Subject: RATTLE NOISE FROM FRONT DOOR GLASS	Bulletin No: 09-038/16
	Last Issued: 06/09/2016

BULLETIN NOTE

2014-2016 Mazda6

2014-2016 Mazda3

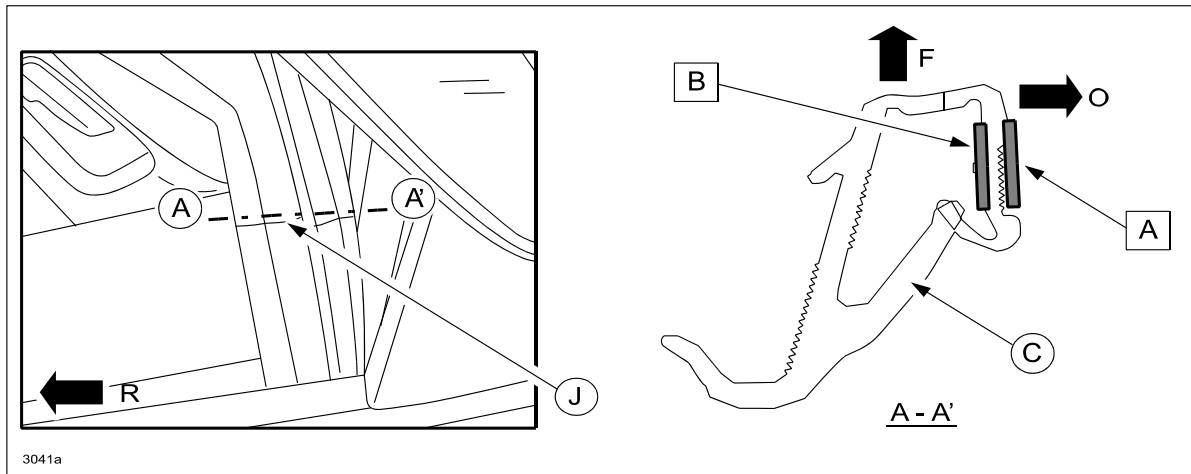
- If the noise goes away, proceed to the next step to attach non-woven pads to **Positions A and/or B** of the glass run channel as shown below.

NOTE: Depending on vehicle type, a non-woven pad or resin foam may have already been attached to Position A. In this case, it is not necessary to attach additional non-woven pads to this position.

(O = Outer, F = Front, J = Molded Joint Line, R = Rear)

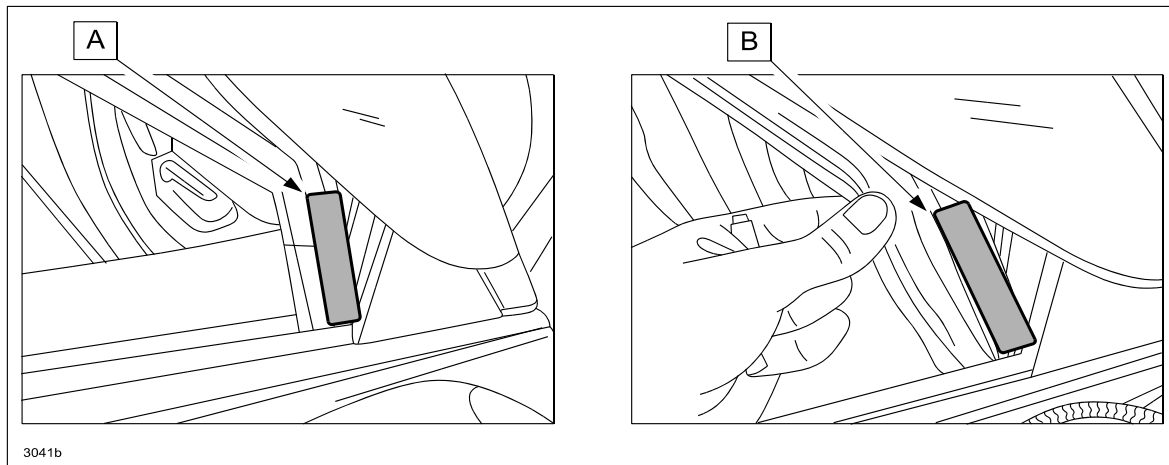
5. Degrease the glass run channel where the pads for **Positions A and/or B** will be attached to the glass run channel.

NOTE: Depending on the vehicle type, degreasing is not necessary for Position A if a non-woven pad or a resin foam has already been attached there.

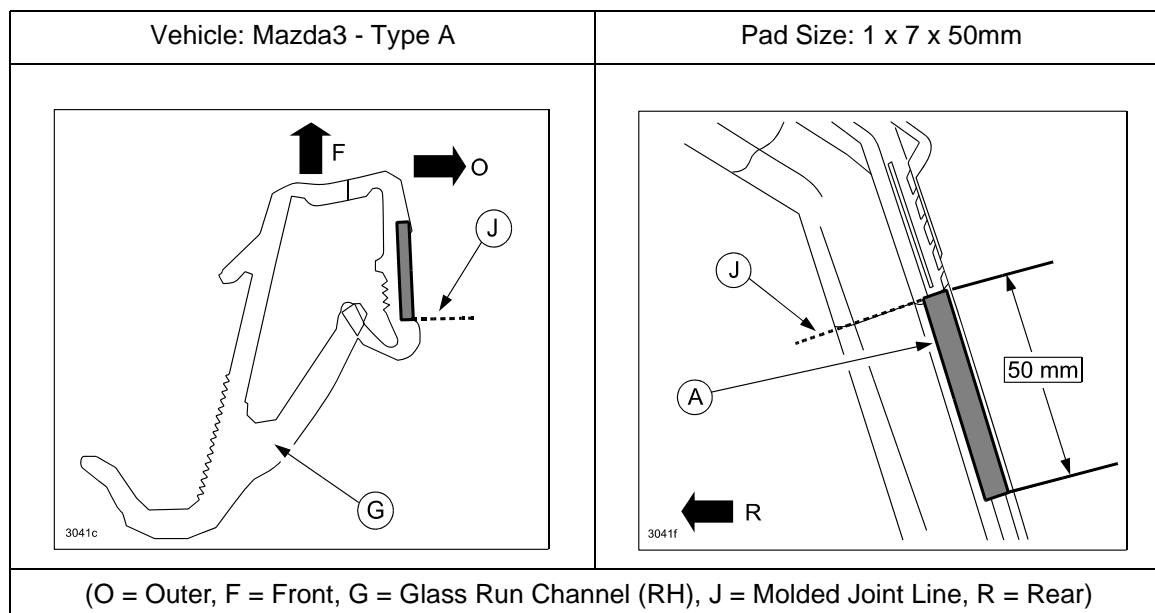
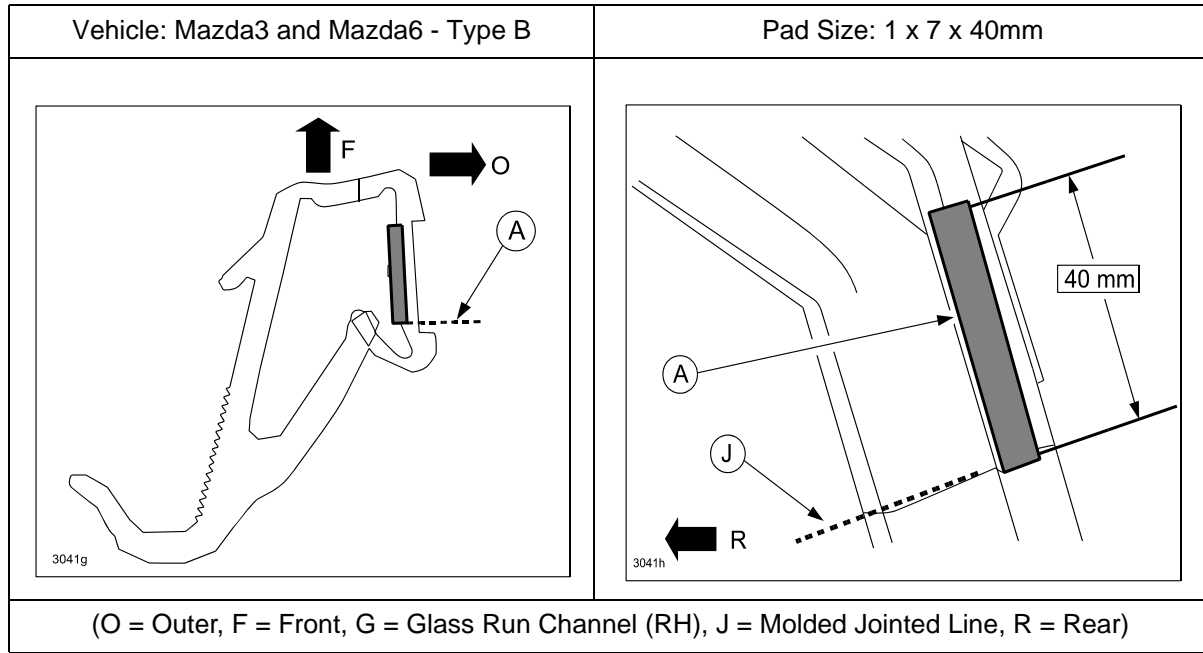
7. According to the vehicle type, attach the non-woven pad(s) to the glass run channel as shown below.

POSITION A: Attach 50mm pad (A) BELOW the molded joint line (J) as shown below.

POSITION B: Attach 40mm pad (A) right ABOVE the molded joint line (J) as shown below.

NOTE: The images below are of a perspective view. Attach the 40mm pad along the uneven line of the back-side of the lip.
